# **Sunshine Coast Airspace and Flight Path Changes**

## **Proposed Final Design and Consideration of Feedback**

**July 2019**

**Figure 7: Runway 13 operations (arrivals and departures)**  
**Yellow Track Arrivals (STARS), Orange Track Departures (SIDS), Red Track (RNAV)**

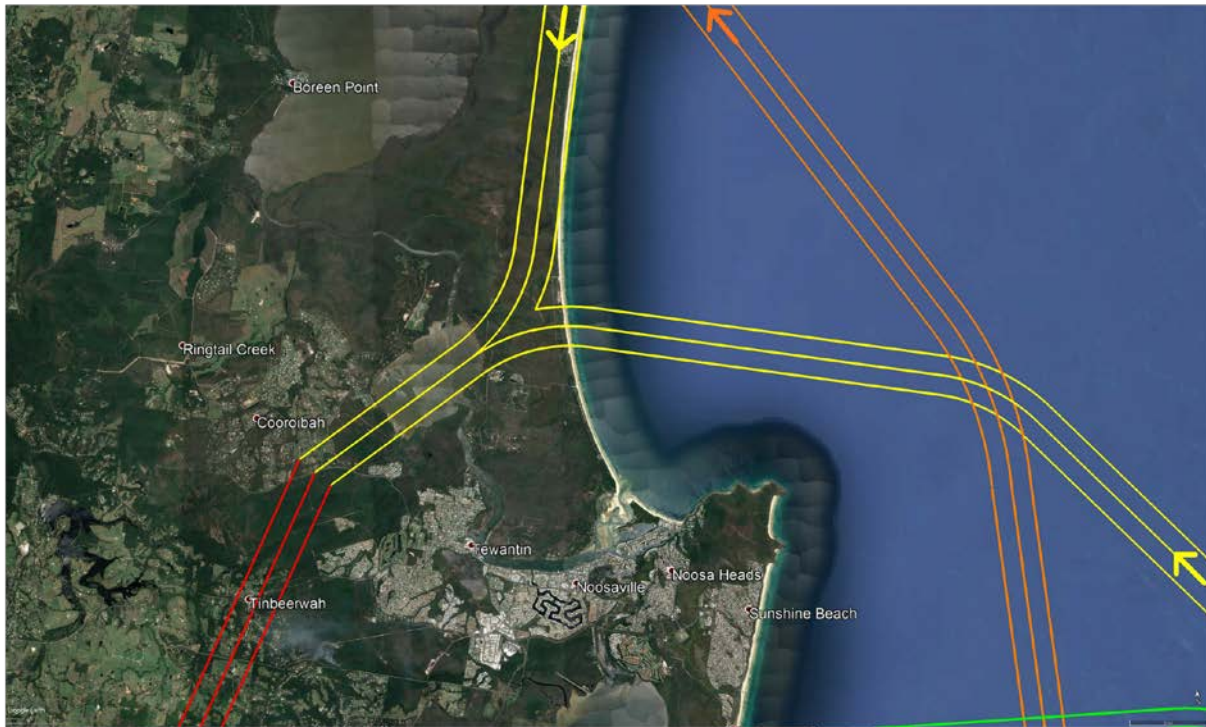
Residents were concerned about the potential for increased noise from aircraft operations in this area, and expressed the need for aircraft to be distributed across the two arrival/approach paths (RNAV and 'Smart Tracking' (RNP-AR)).

This design element has been incorporated in the proposed final design.

**Figure 8: Runway 31 Operations (arrivals and departures)**  
Yellow Track Arrivals (STARS), Orange Track Departures (SIDS)

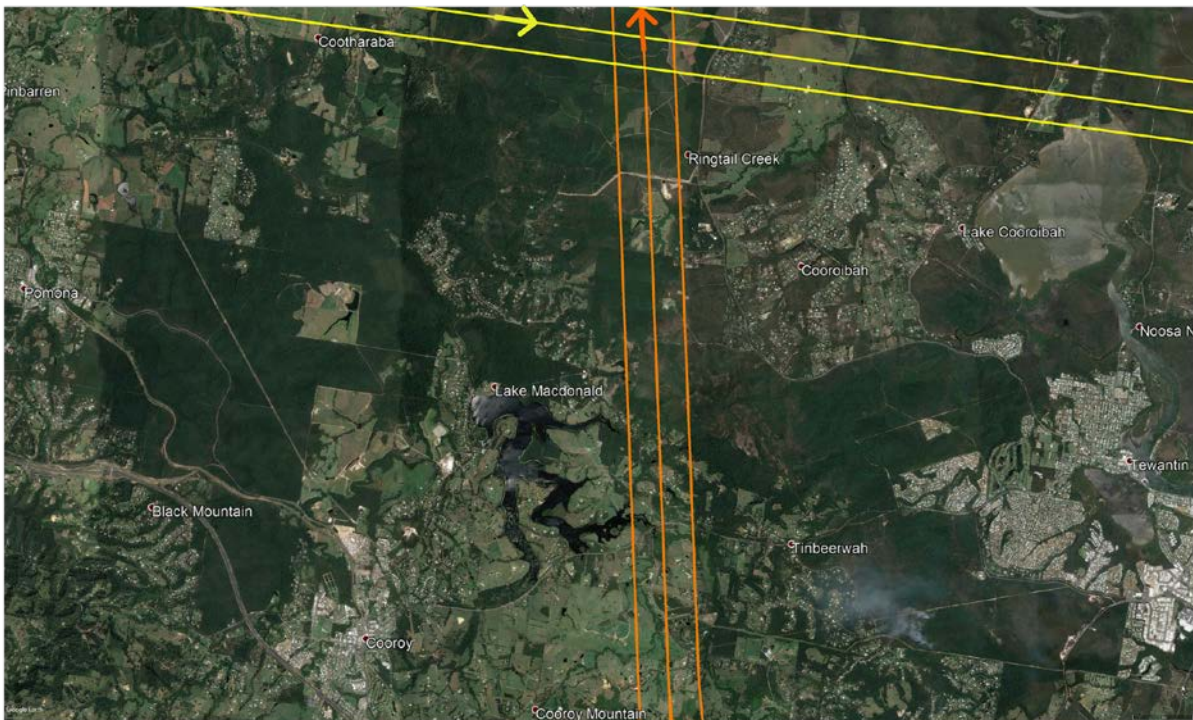
Some community members were concerned about the noise associated with the departure flight path. We reviewed the departure flight path to identify where we could provide a steeper climb gradient so as to have aircraft overfly communities at a higher altitude and to minimise the effect of aircraft noise on these communities.

An amendment to the climb gradient for this departure path has been made to 7%, resulting in departing aircraft achieving higher altitudes and minimising the effect of aircraft noise on the communities overflown.

NAPs will restrict jet aircraft from conducting intersection departures, to ensure aircraft are at higher altitudes when operating over residential areas.

Figure 11: Runway 31 departures - Yellow Track Arrivals (STARS), Orange Track Departures (SIDS)

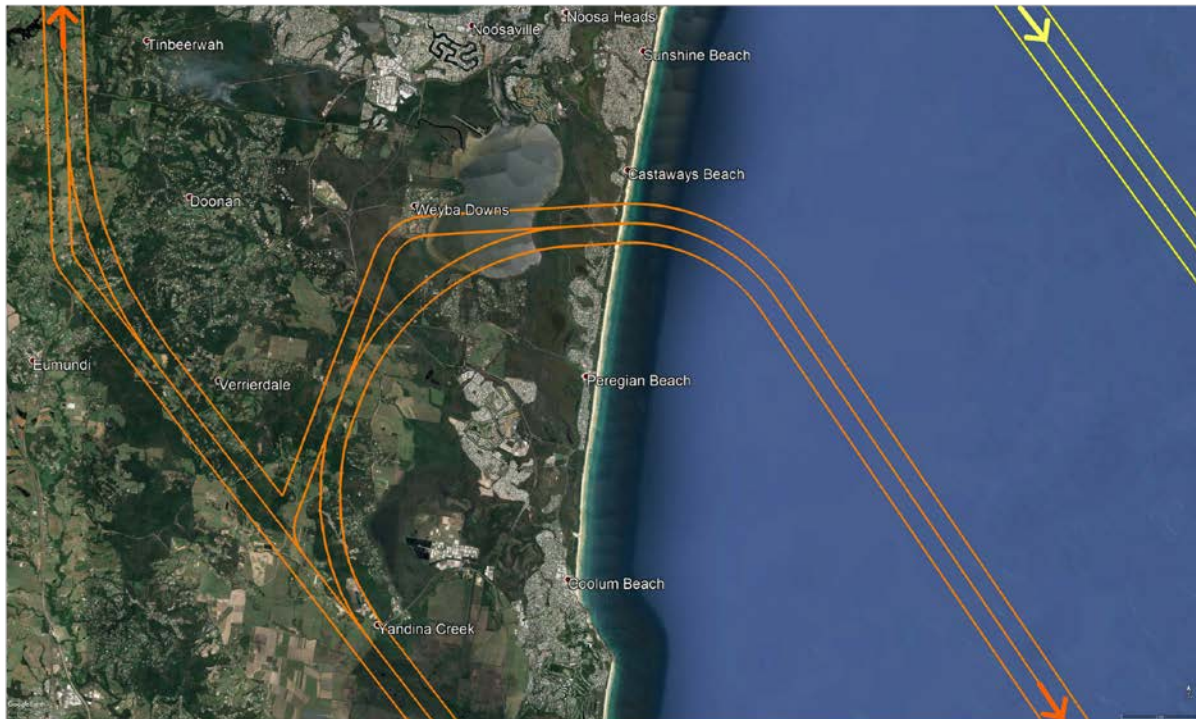
Some community members were concerned about the departure flight path overflying the same communities that were underneath or near the arrival flight path.

The departure flight path could not be adjusted further north or south without directly overflying more populated residential areas. The proposed flight path utilises tracking over less densely populated residential areas near the coast, and includes tracking points known as 'waypoints' that will contain the aircraft operations as much as possible, so as to reduce the area of potential flight.

NAPs will restrict jet aircraft from conducting intersection departures, to ensure aircraft are at higher altitudes when operating over residential areas.

**Figure 12: Runway 13 Operations (arrivals (green track) and departures (Yellow Track Arrivals (STARS), Orange Track Departures (SIDS), Red Track (RNAV), Green Track (RNP-AR))**

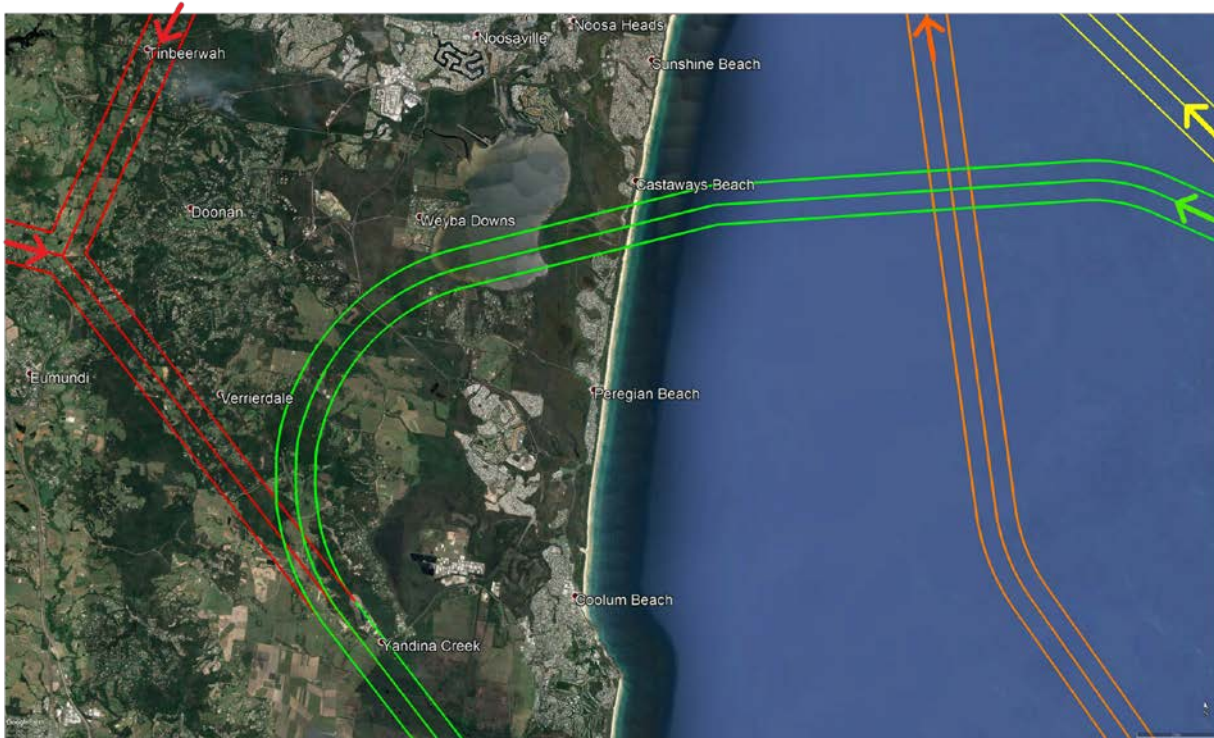
Community members expressed strong opposition to having the 'Smart Tracking' (RNP-AR) approach over their community and either requested that either all flights should operate on the RNAV flight path to the north, or requested alternative proposals to be considered to the west of the airport.

Some community members were concerned that an apparent amendment had been made to the operational description in the approved EIS that changed the description of the 'Smart Tracking' approach from 'secondary' to 'primary' over the Marcus Beach and Marcus Dunes areas.

They believed that this change of terminology would alter the number of aircraft operating on the proposed flight path.

In reviewing the narrative and the graphic that mentioned 'primary' and 'secondary' corridor in the EIS, we identified that there was the potential for confusion among community members about aircraft type, number and operations on each of these flight paths.

With reference to the text below from the EIS, the use of the term 'secondary' was intended to identify that there were 2 approach paths to this airport from the south. It was not intended to reflect forecast aircraft utilization across each flight path.

Consideration was given to airline industry requests for visual approach procedures for jet aircraft onto Runway 13. We made a determination not to proceed with the request as it could expose Marcus Beach residents to potential increased overflight and associated aircraft noise.

Figure 13: Runway 13 Operations (departures) - Orange Track Departures (SIDS), Green Track (RNP-AR)

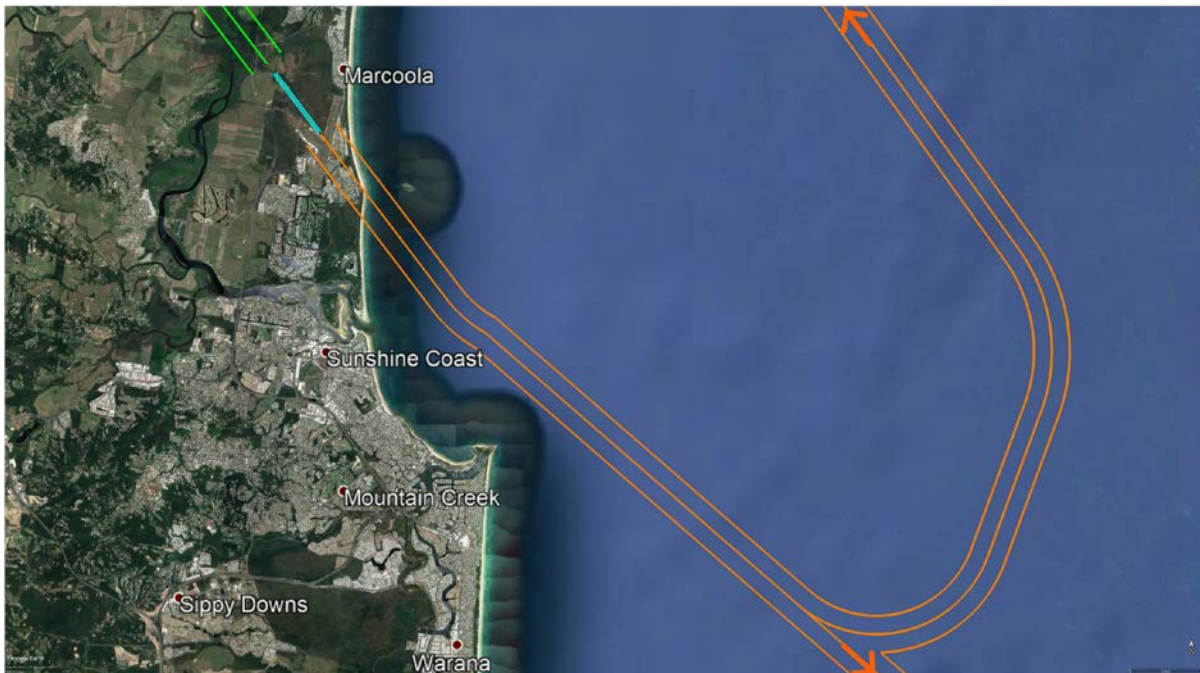
Some community members requested the aircraft turn slightly left after take-off to remain over parklands and reserve areas.

Given the proximity of populated communities to the eastern end of the runway it was determined that the flight path should not be adjusted.

We examined the operations of aircraft and identified that maneuvering the aircraft at low level actually increases the aircraft noise footprint.

Figure 14: Runway 31 operations (arrivals) - Yellow Track Arrivals (STARS), Red Track (Proposed final design RNAV) Blue Track (Proposed design RNAV Track – will not be incorporated in the final design)

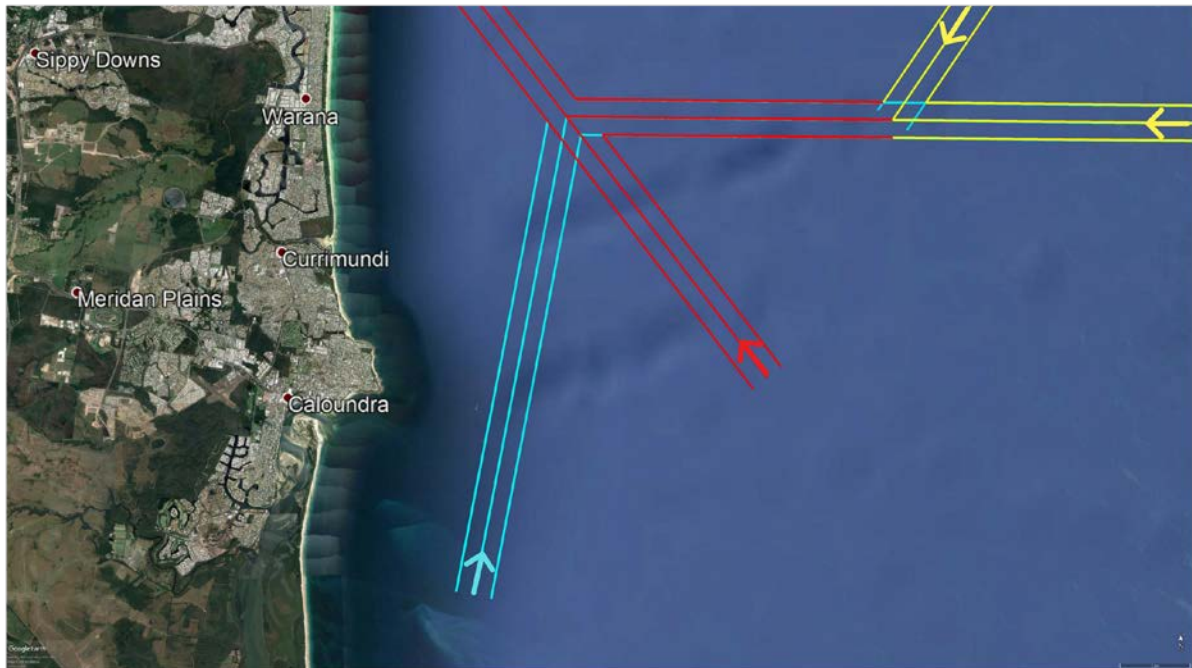
There was minimal response from the community on this design element. However, we examined ways to move aircraft operations further over water to minimise the impact of aircraft on coastal communities.

An amendment has been made to remove the left initial approach point from Runway 31 RNAV. By adjusting the RNAV, aircraft will operate further away from coastal communities, minimising the noise and visual impacts of aircraft operations.

**Figure 15. Runway 31 operations (arrivals)**  
**Green Track (Proposed final design RNP-AR), Blue Track (Proposed design RNP-AR – will not be incorporated in the final design)**

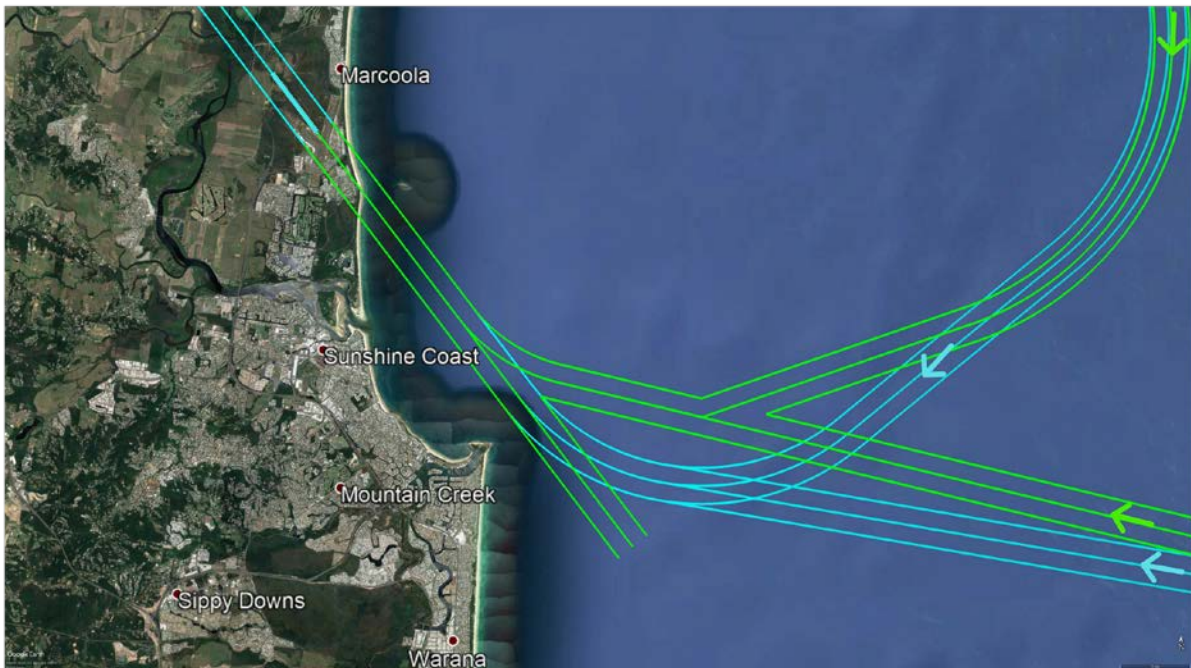
There was minimal response from the community on this design element. However, we examined ways to move aircraft operations further over water.
